PLANNING COMMISSION AGENDA
DECEMBER 12, 2019 – 6:30 P.M.

RE: Conditional Use Permit – Initial Review Response Letter
Proposed Casey's – 118th & Harrison
Lot 3, Harrison Hills
Convenience Store & Gas Station
Schemmer Project No. 06754.064

RE: Planned Unit Development – Initial Review Letter
Lot 3 Echo Hills

RE: Echo Hills Planned Unit Development Review Letter
Lot 3 Echo Hills
TD2 Project No. 2142-102.2

Exhibit C

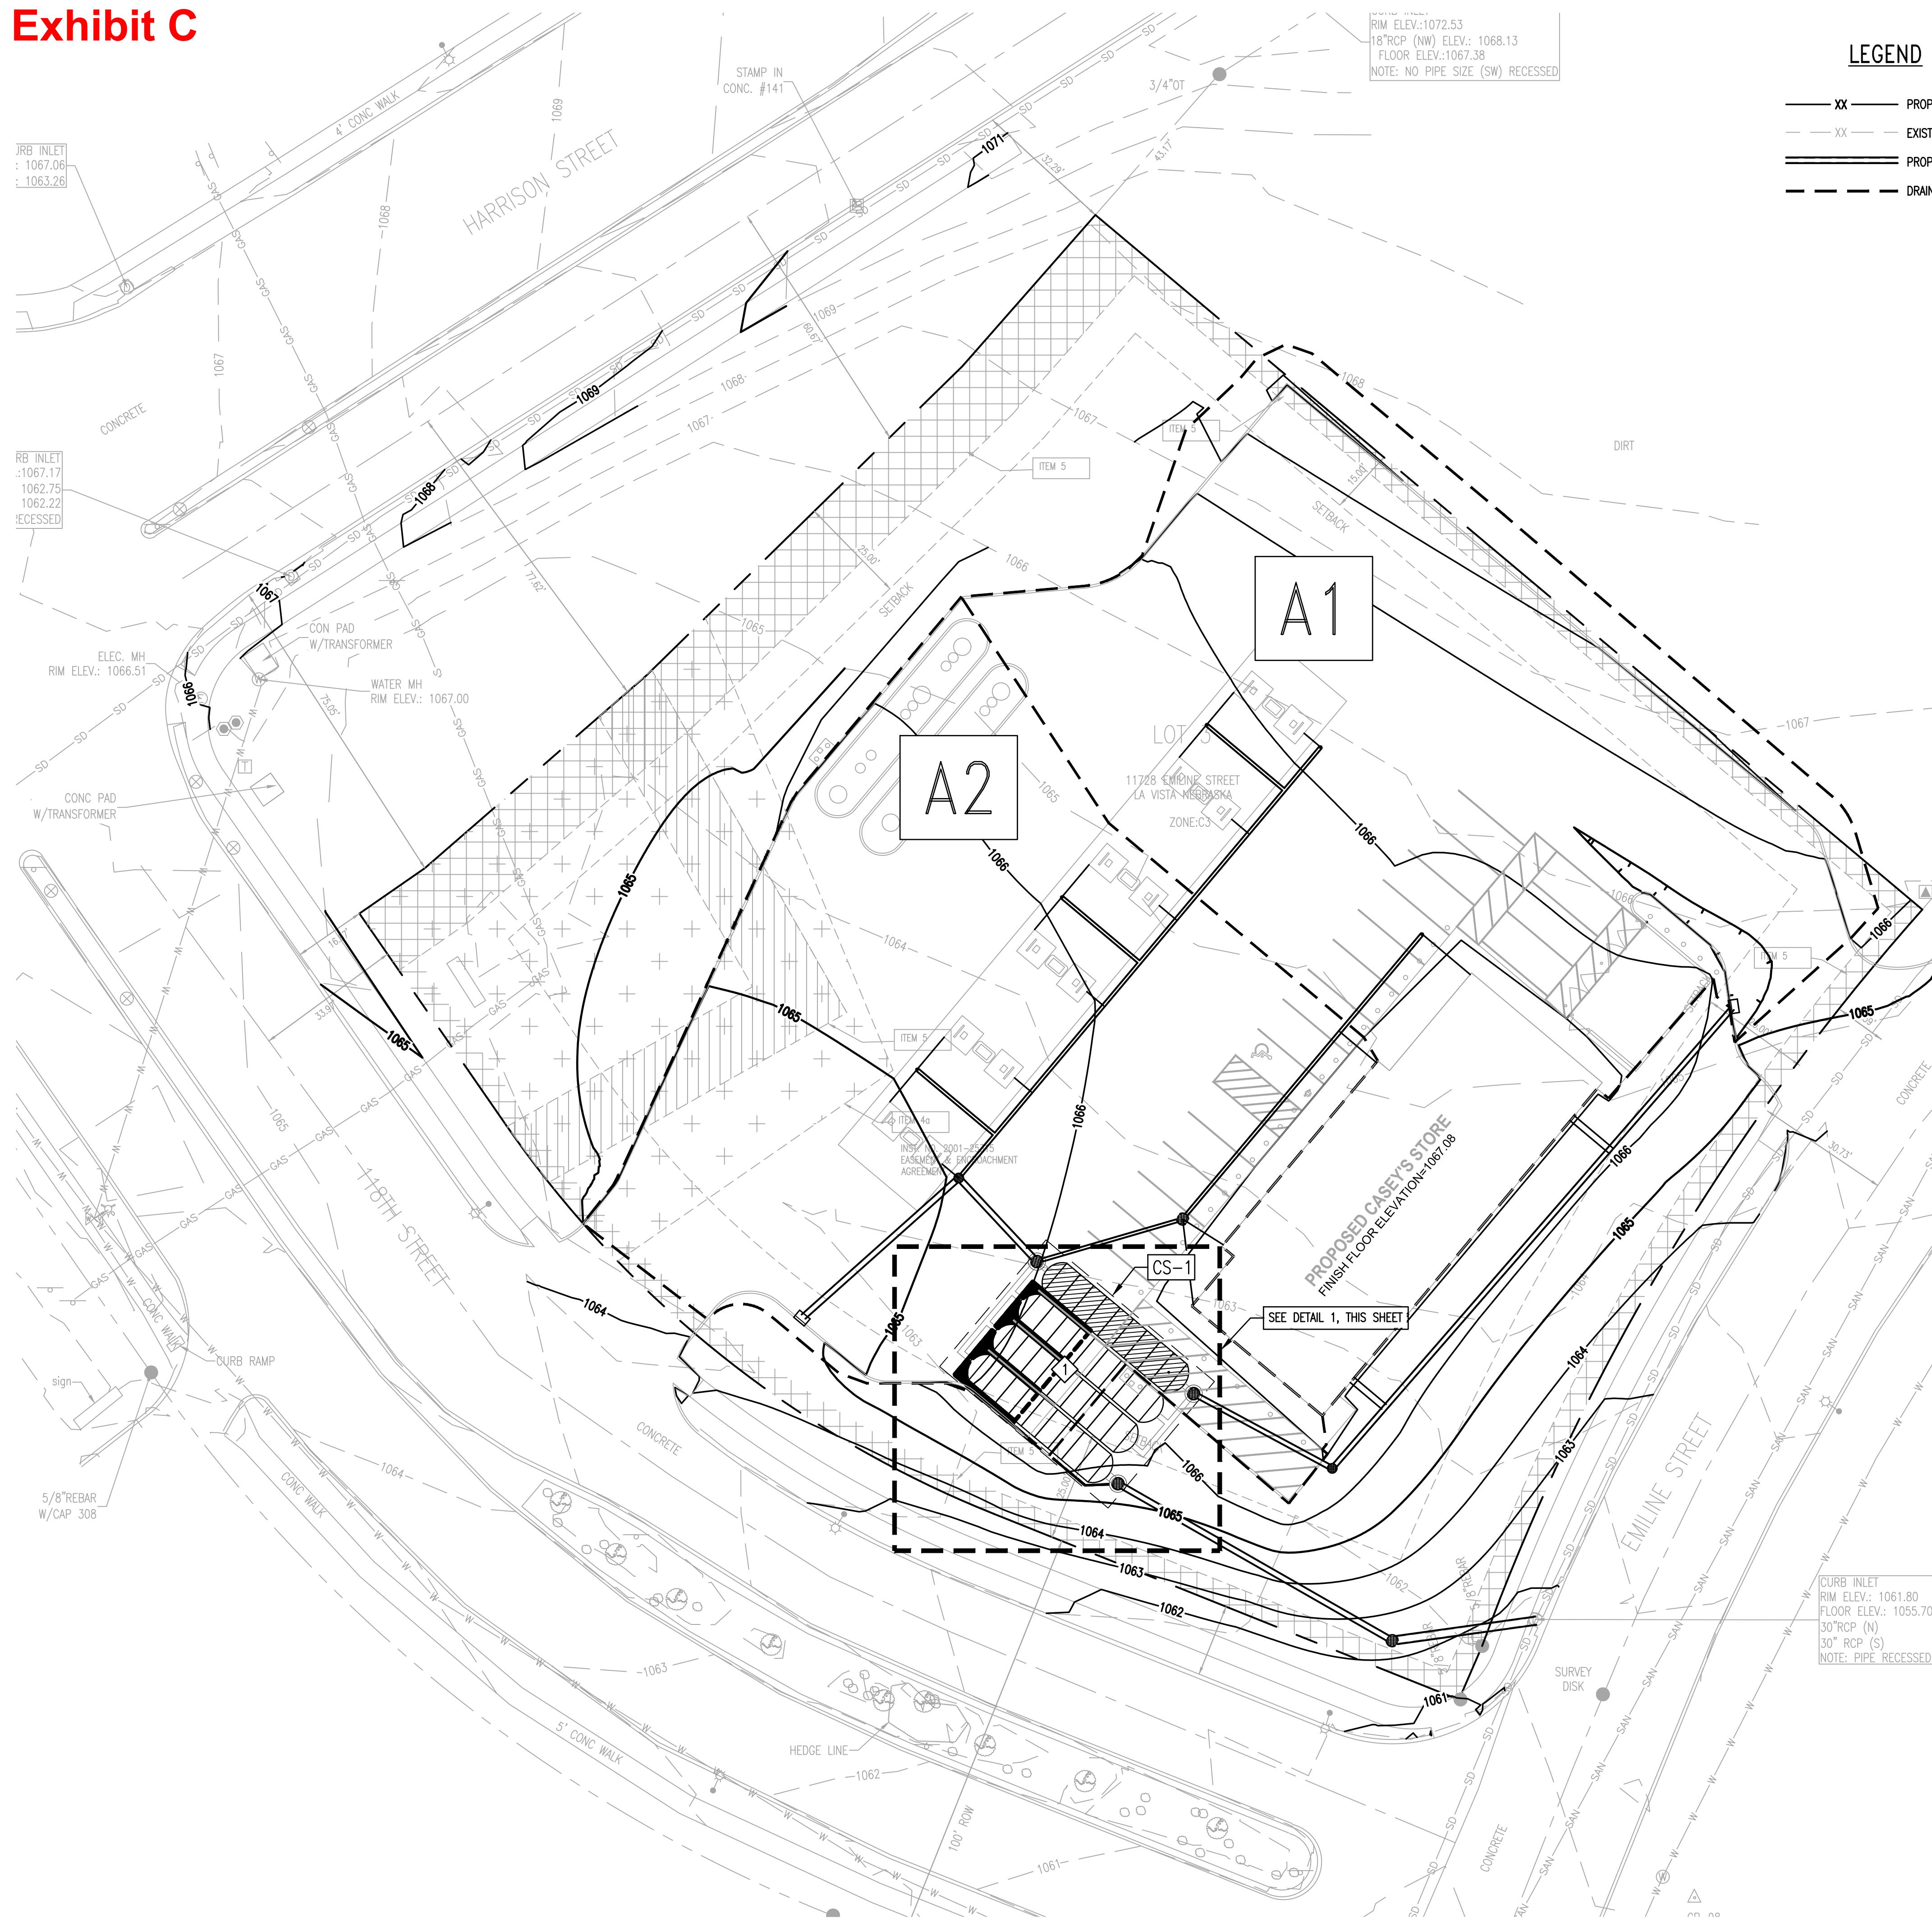
3. Regarding Articles 6.05.04, the proposed Site Layout Plan needs to identify type and location of best management practices that will be used to address water quality and no increase in 2-year storm event peak flows above pre-development conditions. Detailed design is not required, just an indication as to how this will be addressed.

5. In regards to Article 6.05.09, site lighting will be reviewed as part of the design review process.
6. The zoning listed on the site plan needs to be revised to include "Gateway Corridor District (Overlay District)".

7. Strike "Misc. Notes" #1 as the dumpster design will be handled through the design review sheet set.
8. Strike "Misc. Notes" #2 as the signage will be handled outside of the Conditional Use Permit approval process.

- a. A StormTech® underground detention system is proposed for this site. A Post Construction Stormwater Management Plan is attached to this email.
- 4. Regarding Article 6.05.03, the Site Layout Plan proposes a shared driveway with the adjoining Lot 4 to the east. The owner of the adjacent lot needs to provide a written statement that they are agreeable to the proposed shared access. A finalized easement including maintenance provisions will be required prior to issuing a building permit.

- a. We have modified the site plan to only include a driveway on our lot and it is attached to this email.
- 5. In regards to Article 6.05.09, site lighting will be reviewed as part of the design review process.

- a. The zoning listed on the site plan has been revised to include "Gateway Corridor District (Overlay District).
- 7. Strike "Misc. Notes" #1 as the dumpster design will be handled through the design review sheet set.

- a. We removed this note from the site plan.
- 8. Strike "Misc. Notes" #2 as the signage will be handled outside of the Conditional Use Permit approval process.

PUD

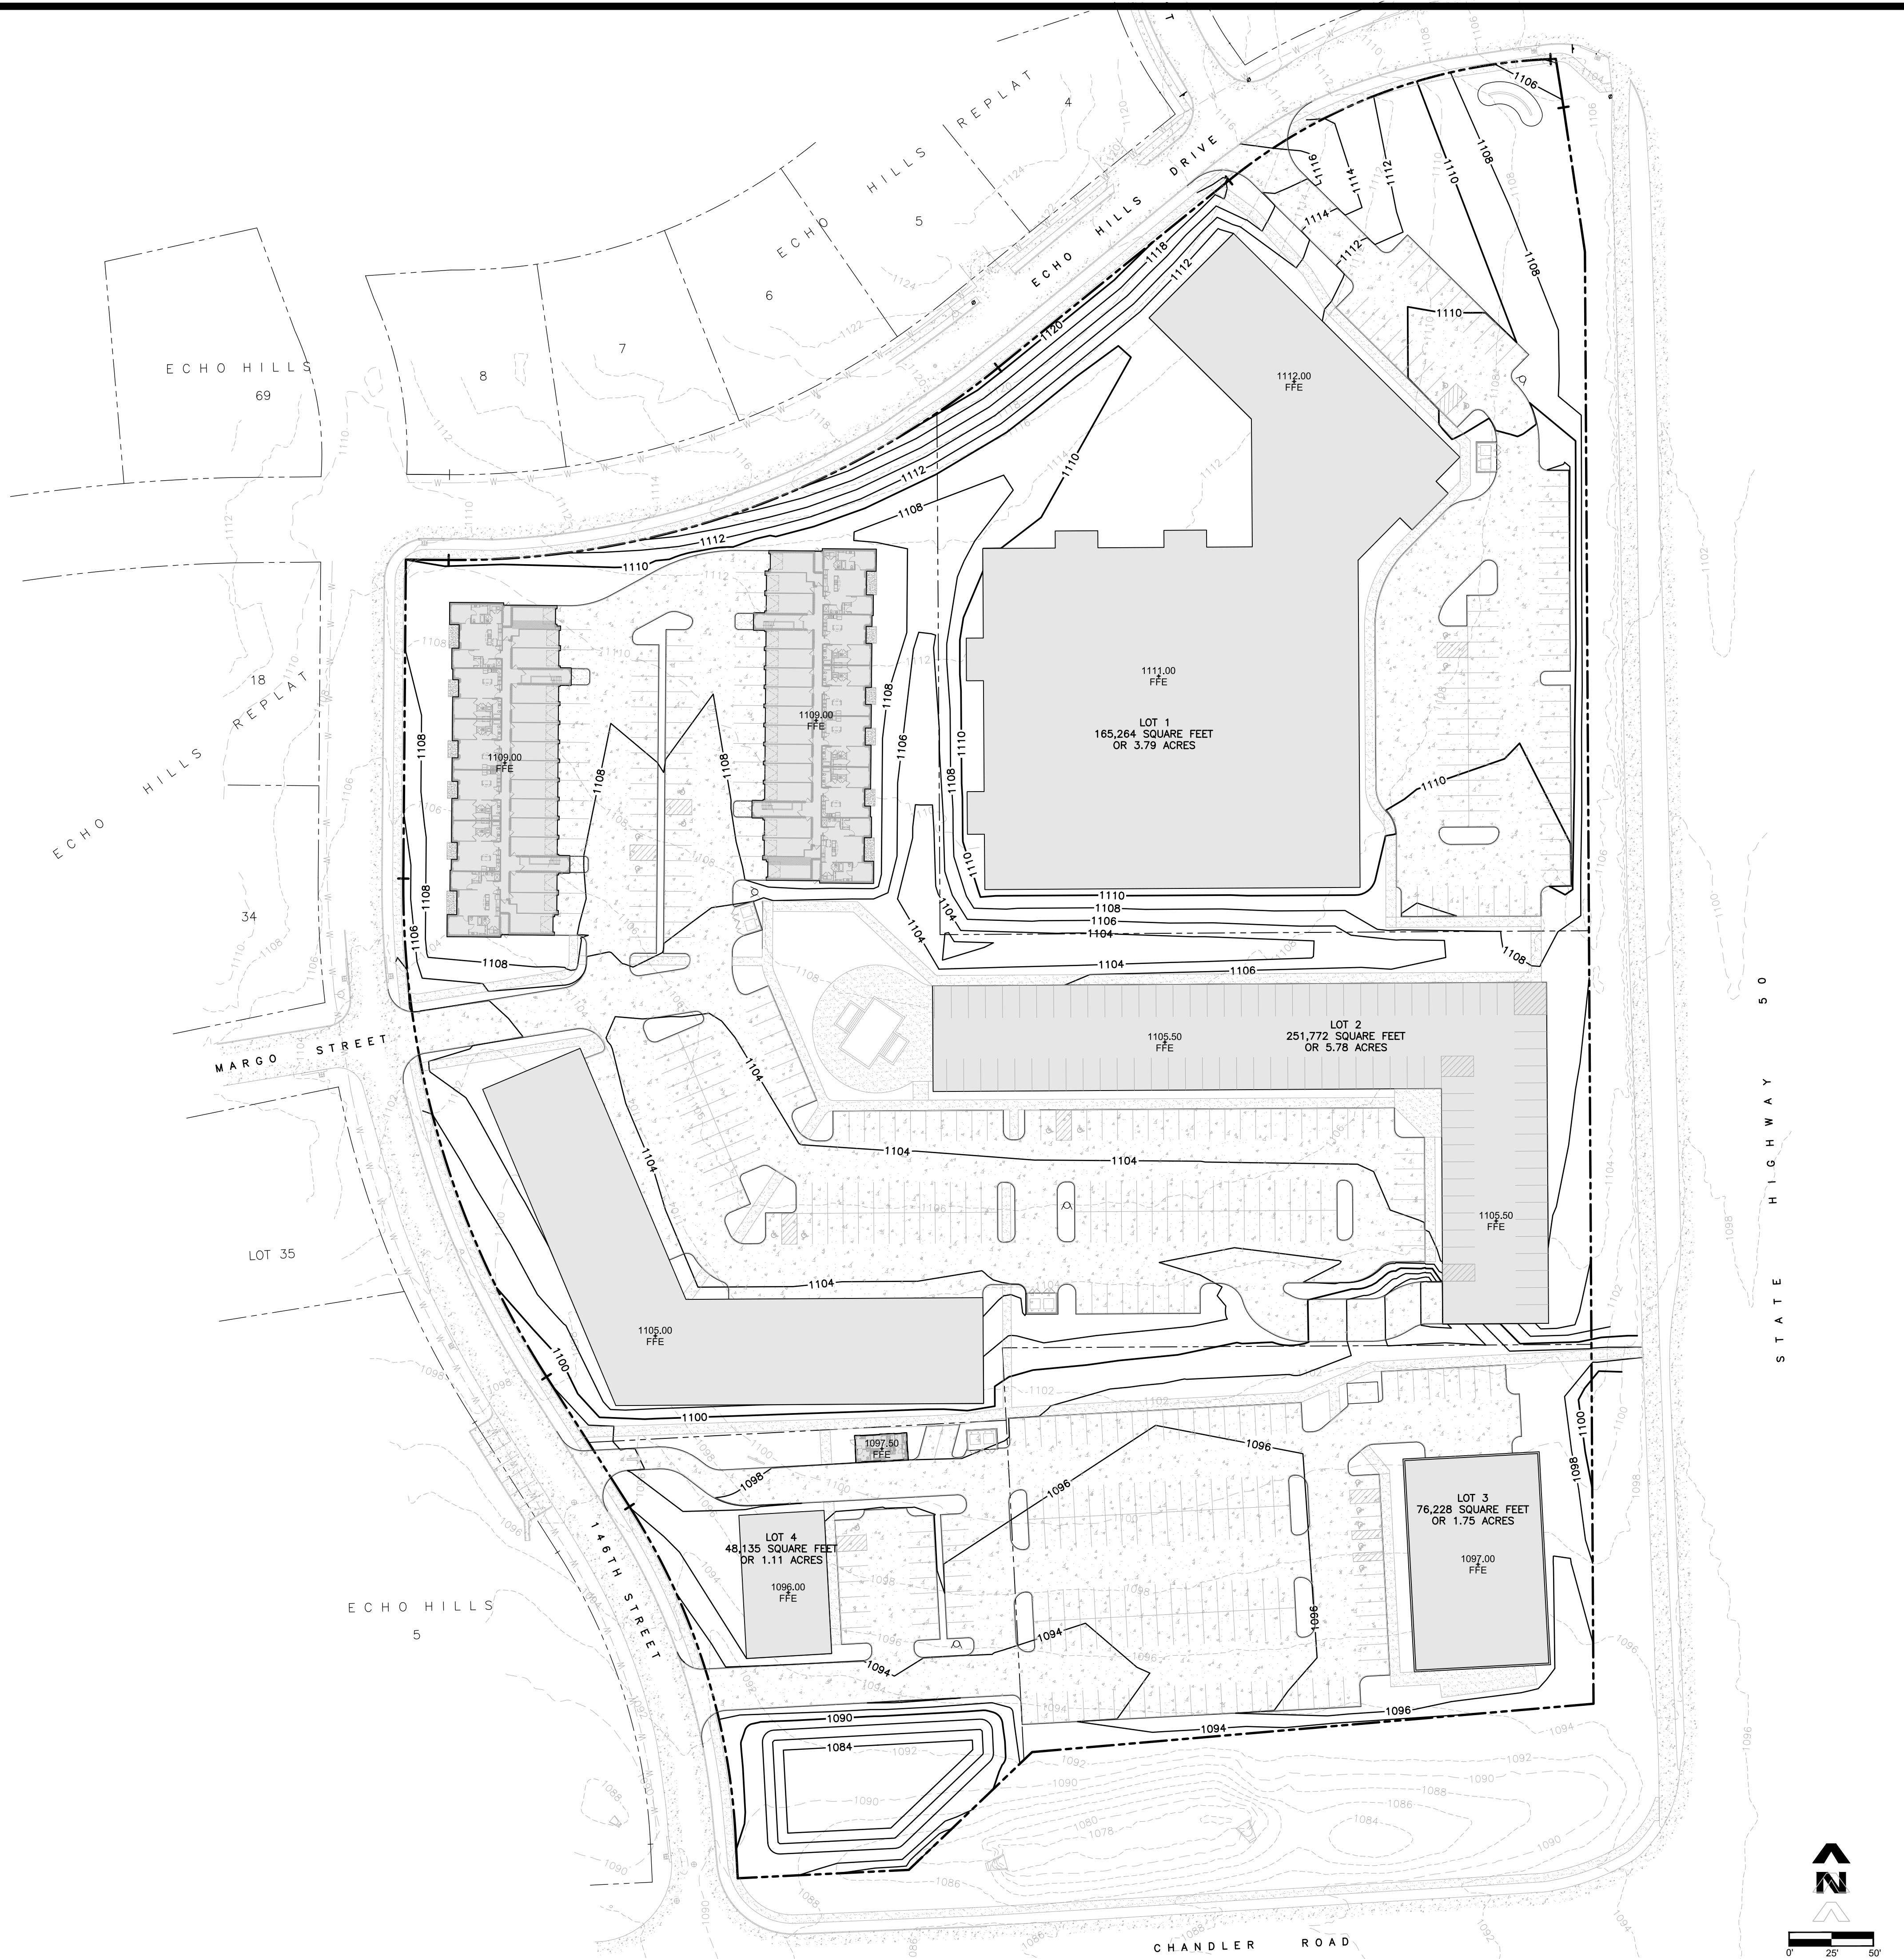
1. Section 5.15.03 – The zoning listed on the PUD Site Plan needs to be corrected to include the Gateway Corridor District (Overlay District) over all parcels to reflect the actual zoning.

6. Section 5.15.04.07 - Parking requirements appear to be adequate for lots 2, 3 and 4. Lot 1 does not meet the requirements per 7.06 of the Zoning Ordinance. Please show how assumptions were calculated, and what provisions will be taken to ensure parking will not become an issue in the future. Some stalls in Lot 2 and Lot 4 appear to be less than standard length of 18 feet, however this may be due to overhang. Applicant should confirm all stalls are standard dimension, otherwise provisions should be made for compact parking.

7. Section 5.15.04.09 – The residential structures within the PUD Site Plan do not meet the 30-foot front yard setback requirement of the proposed underlying R-3 Zoning District. However, these setbacks do meet the minimum requirement of Section 5.15.04.09 of the Zoning Ordinance when found reasonable by the Planning Commission and City Council as per that section of the Ordinance.

10. Section 5.15.04.15 - PUD plan needs to show five foot (5') wide sidewalk dimensioning on public street frontages.
11. Section 5.15.04.17-20 - The overall site and landscape plans are currently under review by the City's Design Review Architect. A separate design review letter will be forwarded once the initial review has been completed. The design review process for these plans needs to be substantially complete prior to proceeding through City Council approval process.

1. Section 5.15.03 - The zoning listed on the PUD Site Plan needs to be corrected to include the Gateway Corridor District (Overlay District) over all parcels to reflect the actual zoning.
Okay, Site Plan has been updated.

Acknowledged. Label has been added.
